PLANT NAME: COOK UNITS 1 & 2
jcm 12/23/77

ENCLOSURE
Consists of detailed information on the steam generator and reactor coolant pump support materials and evaluation of the fracture toughness and potential for lamellar tearing of the support materials...w/att mill certifications and support drawings

Donald C. Cook Nuclear Plant Unit Nos. 1 & 2
Docket Nos. 50-315 & 50-316
DPR No. 58 and CPPR No. 61

Mr. Don K. Davis, Acting Chief of Operating Reactors Branch #2, in his September 14, 1977 letter to us, requested that we supply detailed information on the steam generator and reactor coolant pump support materials and our own evaluation of the fracture toughness and potential for lamellar tearing of the support materials. Attachment I is our response to the above request. Specifications for detailing, fabrication and delivery of equipment supports are given in Attachment II. Attachment III and Attachment IV present mill certifications and support drawings respectively.

Figure 1 Steam Generator Lower Support Model

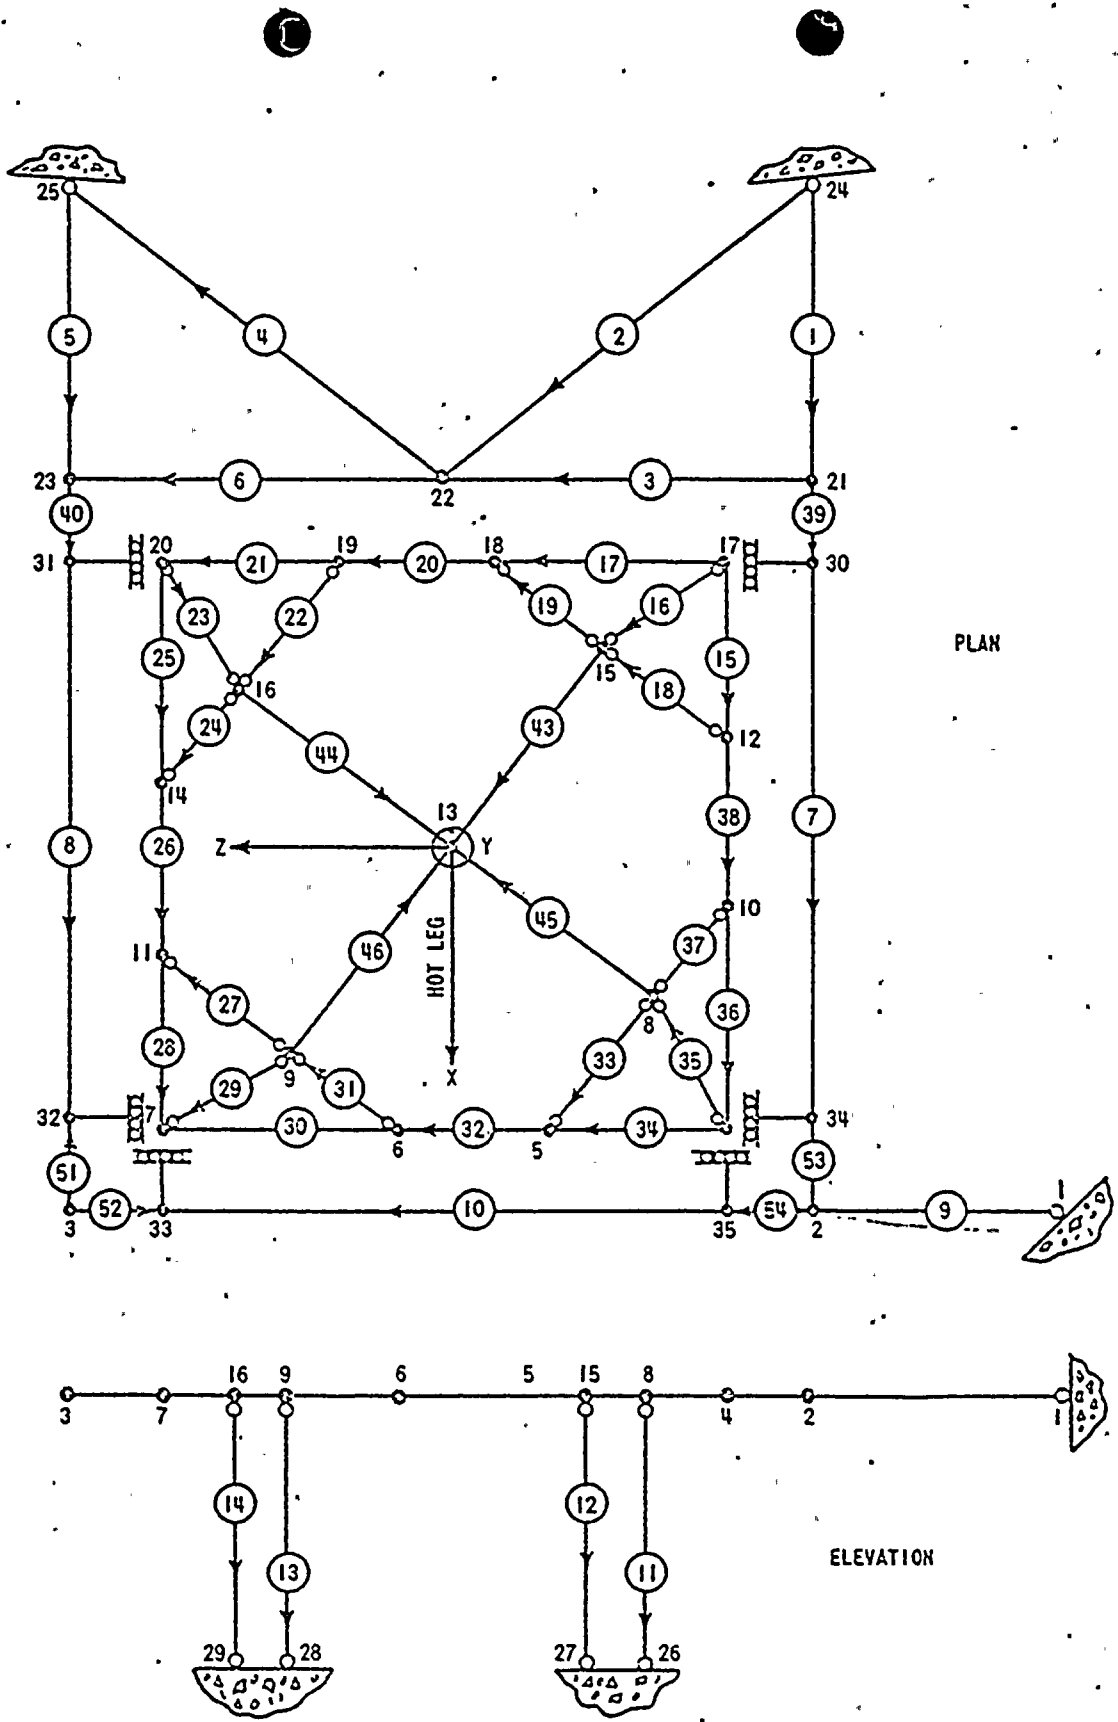
Specify the detailed design loads used in the analysis and design of the supports. For each loading condition (normal, upset, emergency and faulted), provide the calculated maximum stress in each principal elements of the support system and the corresponding allowable stresses.

The detailed design loads as provided by Westinghouse for the steam generator in report SD104 are given in the first 13 tables. Member stress levels expressed as a percentage of the allowable stress for the upper and lower supports are provided in tables 14 and 15. Figures 1 and 2 are provided to identify the elements of the steam generator supports. The loads for the Reactor Coolant pump supports are provided in tables 16 through 26. Tables 18 through 26 include both the loads and the margin of safety under the faulted condition for the R.C. Pump supports. Figure 3 is provided to identify the members. Stress levels for the R.C. Pump supports for the load cases normal, upset and emergency are provided in Table 27. Figure 3 identifies the elements for Table 27. The allowable stresses for each load condition and a description of the loading conditions themselves are provided in the following paragraphs.

In all cases the faulted condition controls the design. The maximum stress level found for the faulted condition for the steam generator lower lateral support was 84% of the maximum

*These loads are applied to node 13 of the model shown in Figure 1.

+See Figure 1 for member locations.
